REFERENCE	BT_2011_X85CUP_10
DATE	2011 September 1st
SUBJET	Front damper external evolution

CONCERNED: ALL CHAMPIONSHIPS

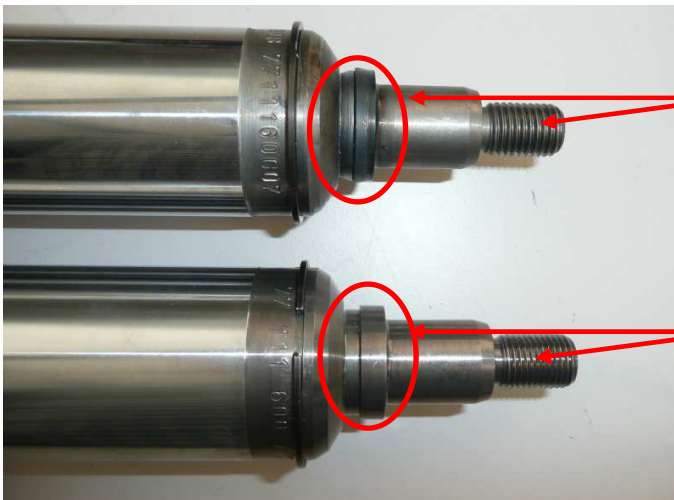
We want to inform you about a front damper evolution.

The reference is the same (77 11 160 007) but the new generation presents some external different characteristics:

1) upper point fastening

Old version :
thread M150 + welded spacer

New version :
thread M125 + full machined area

2) lower cap

New version :
Black plastic cap

Old version :
metal cap

→ The corresponding locknut is delivered with the new damper

→ The valving / setting remain strictly unchanged

Both versions are now allowed in all our championships.
